RESOLUTION ON REQUEST FROM HUBBELL REALTY COMPANY TO AMEND THE DES MOINES' 2020 COMMUNITY CHARACTER PLAN FUTURE LAND USE DESIGNATION (4209 LOWER BEAVER ROAD)

Communication from the City Plan and Zoning Commission advising that at their meeting held November 5, 2015, the following action was taken regarding a request from Hubbell Realty Company (purchaser) represented by Joe Pietruszynski (officer) to rezone property located at 4209 Lower Beaver Road. The subject property is owned by Lower Beaver, LLC.

STAFF REPORT TO THE PLANNING COMMISSION

CONCEPTUAL PLAN FOR WOODLAWN

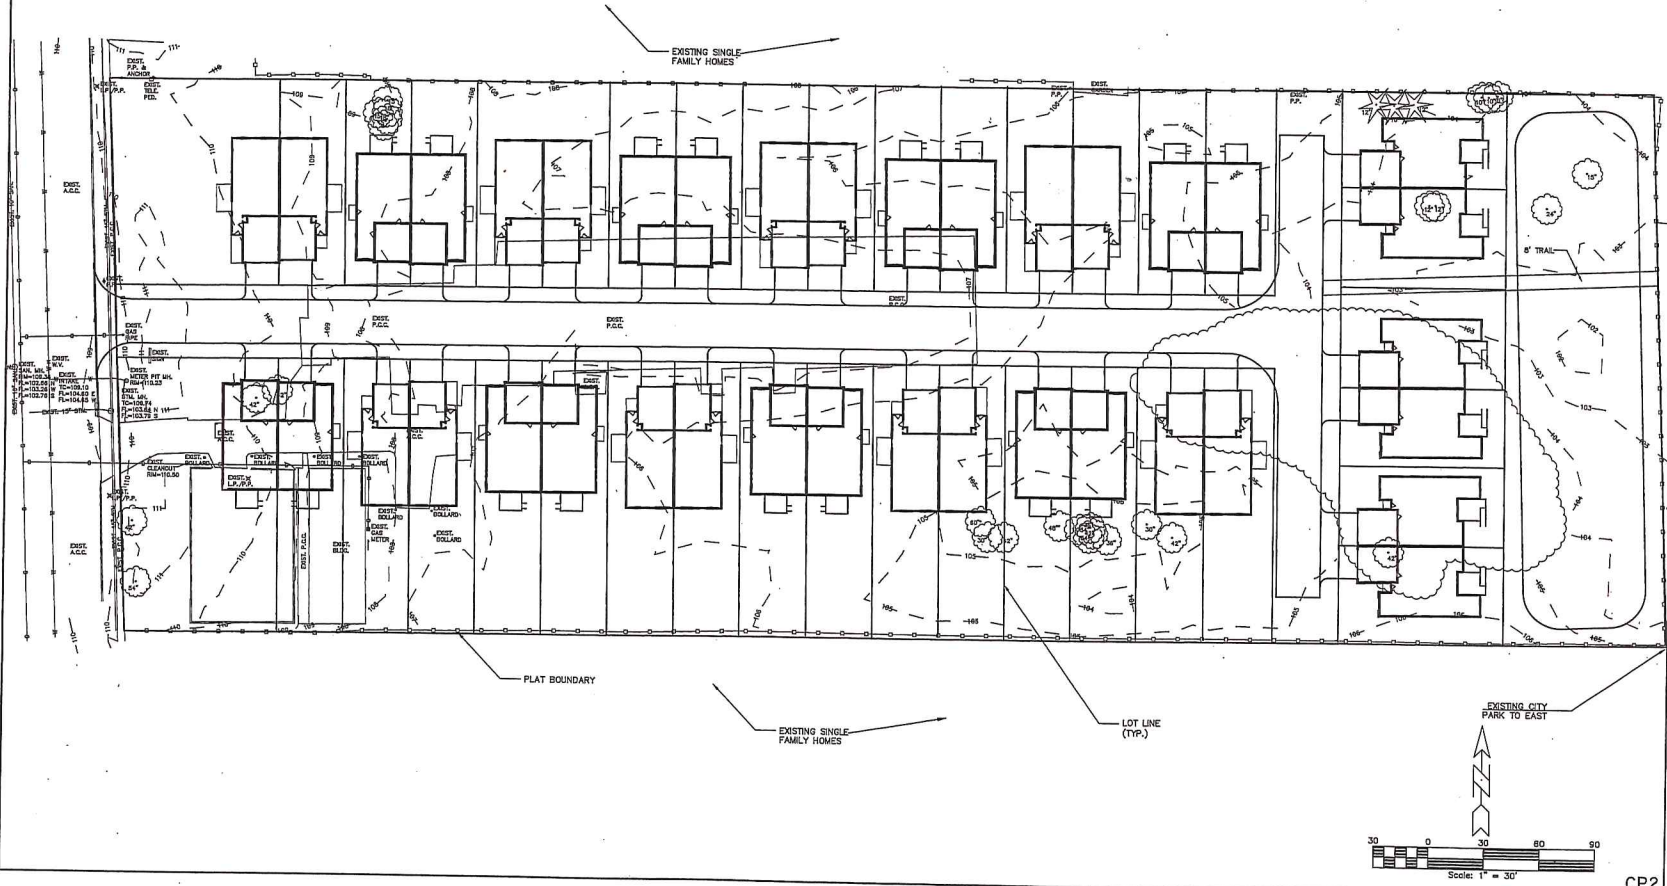
1. Provision of a statement that all development shall comply with the City's Tree Protection and Mitigation Ordinances.
2. Revision of the stormwater management statement to further indicate that storm water management would shall be required to detain storms for both water quality and for overall flood control purposes, holding between 2-100 year storm events and releasing at pre-developed rates in accordance with SUDAS Section 2G-1. Any detention basin shall be required to release the larger storms at two or more points or otherwise spread the release to minimize potential for erosion.

4. Provision of an 8-foot wide pedestrian walk integrated into the north side of the private drive running from Lower Beaver Road to align with the proposed trail connection to Woodlawn Park.

- There shall be at least 10 feet of total separation between any portion of the side facades of any two buildings.
 - There shall be a minimum 5-foot differential between any two adjacent buildings of the setback of the building from the private drive.

Brian Millard stated there have been two issues expressed by everyone over and over. One is a huge amount of water coming off of this property. It sheets across the property and is going on to properties along Valdez Drive. Two is the offset street that the applicant is being forced by the City to do causing the bi-attached units to be a lot closer to the homes along Twana Drive.

Don Corigan 3316 Twana Drive stated his concerns are the density, parking, and drainage. The location of the units is not centered. He believes that Twana Drive is becoming a busy street. With traffic coming towards Twana Drive going north there is going to be a very short distance for him to see that traffic coming at him. He would like to see that area become a park or more of a villa style residential. He is in the demographics that the applicant was talking about and he believes that their proposal is not attractive. He is big on walkability and would like to see sidewalks on both sides of the street. Lastly, he would like the property renamed to the Beaverfield Project after the historic use of this site.

Terry Lockard 3304 Twana Drive stated she would like the Commission to receive and file petitions they have taken around to the neighborhood. She is asking that the applicant's request be denied from a PUD and maintained "R1" because of the high multi-family concentration that's already existing in the area. There are the apartments and duplexes on Valdez Court. She points out that her home is one of the homes that has vinyl and she did that so that she could stay in her home. She has tried to make it maintenance free on the outside so she doesn't have to move into a townhome situation. She believes there are other ways you can stay in your own home and still maintain it. She does not understand the turning point, the 15 feet setback is a concern because she was told by PZ with that 15 feet on the north and south side they could potentially add on to their property up to that 15 feet point. She would like to see the street centered if this is going to happen.

WOODLAWN - BUILDING ELEVATION

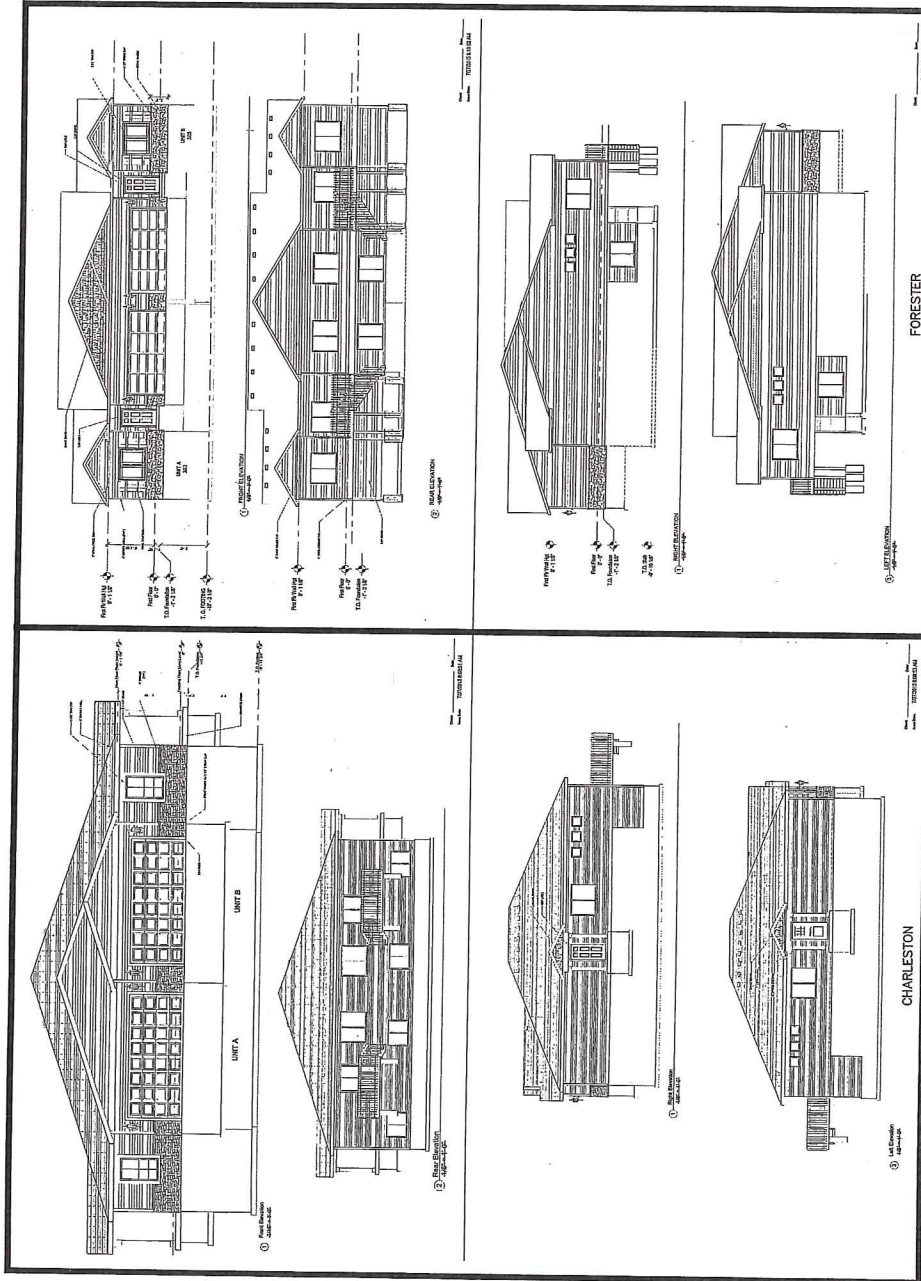
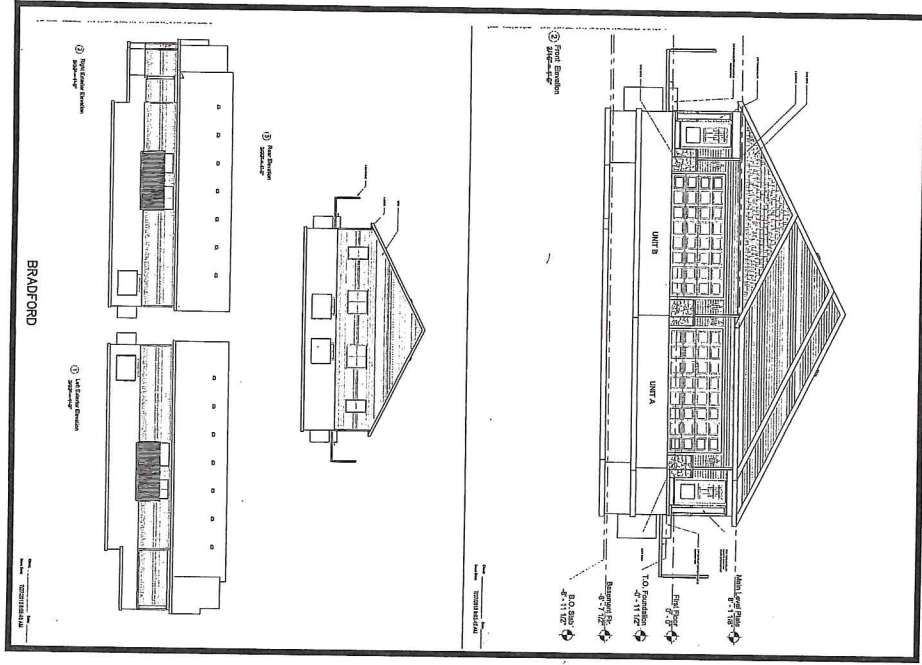
9. **Urban Design:** The submitted development concept includes renderings of the proposed unit design. There are three different unit types being proposed. These designs. All propose vinyl lap and shake type siding materials with asphalt shingle roofs. There is a brick or stone wainscot across the front facades of all the units. Two of the unit plans (Forester and Bradford) have front facing entrances, while the third plan (Charleston) proposes entrance porches which would be side facing.

To achieve compatibility with the adjoining single-family residential development, staff believes that all non-stone or non-brick should be a cement board type siding material for longer lasting durability. While vinyl may offer a lesser level of maintenance in the short term, it does not give the same long term durability as cement board.

- All lap siding shall be cement board, wood, or engineered wood with a minimum 50-year warranty.
- All windows within portions of the façade sided with lap or shake siding shall include a minimum 4-inch wide trim board that is painted a different color than the lap siding.
- All garage doors shall have windows on the upper panel.
- There shall be a contrasting trim band between gabled façades and wall façade elements.
- All dwelling units shall have architectural asphalt shingles.
- There shall be at least 10 feet of total separation between any portion of the side facades of any two buildings.
- There shall be a minimum 5-foot differential between any two adjacent buildings of the setback of the building from the private drive. This will help articulate the lineal views and prevent a straight row or barracks effect.

Structures fronting the private access road would all be one of two designs that are differentiated by varying amounts of stone material, horizontal lap siding, and shake-pattern siding. Staff recommends that the highly visible side facades of the buildings along Lower Beaver Avenue include the brick or stone wainscot to the side and rear façades oriented toward the public street.

In order to preserve the character of the neighborhood, front door entrances should be oriented toward the private drive for all units. This would require an adjustment to the Charleston type design.

Joe Pietruszynski stated they do not agree to staff's architecture standard. The staff talks about 5' staggering of the homes as you move down the street. They are not necessarily against that, but there may be some stormwater constraints. They want to make sure that it all works. The architecture requirements mainly pertain to the garage door. The upgrade is very expensive to put windows on the garage door and the other that is real expensive is to move from a vinyl siding to a hardi-style and then moving into painting will add significant cost.

Condition #6 bullet point 1 "All lap and shake style siding shall be cement board, wood, or engineered wood with a minimum 50-year warranty". They cannot meet that standard with

the price plans of housing. They are asking that they apply the same type of vinyl material as they do elsewhere in the metro.
